# LiDAR Quality Assessment Report

## WI\_MonitowacCo\_2015

NGTOC  
2017-02-03  
Jessica Self

Checkpoint Distribution Image

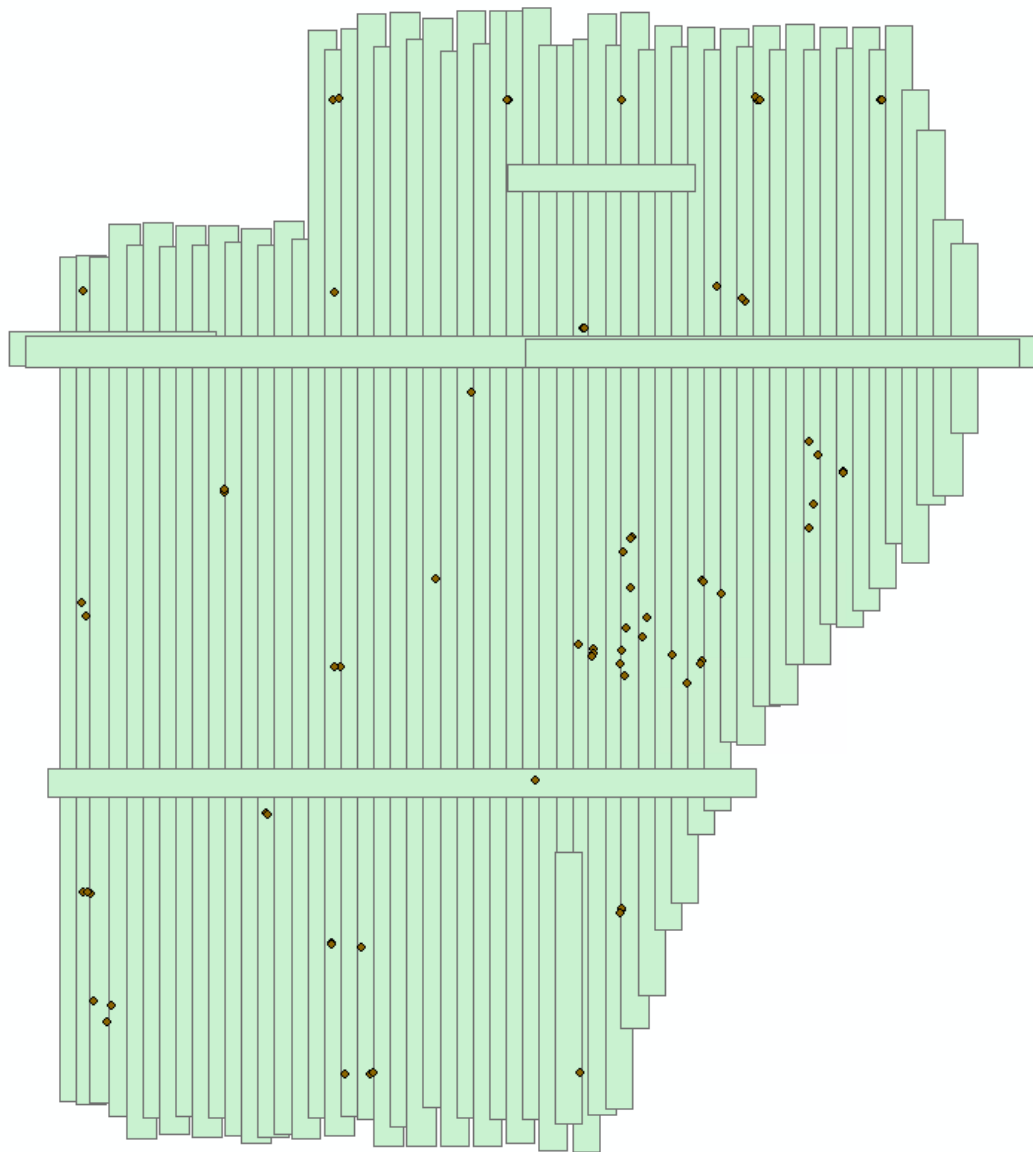
Based on this review, the USGS accepts the vertical accuracy.

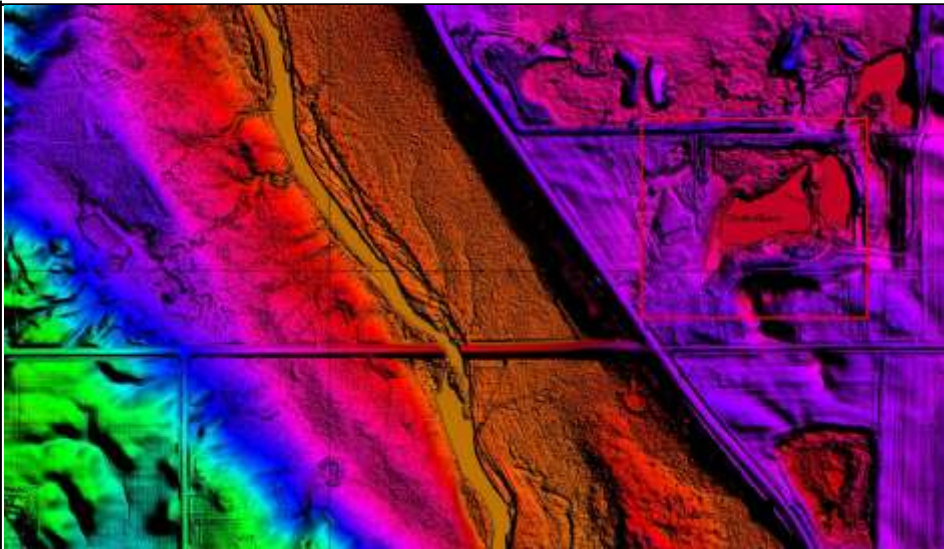
One area needs to be hydro flattened. Water body in 3.22 Acres.
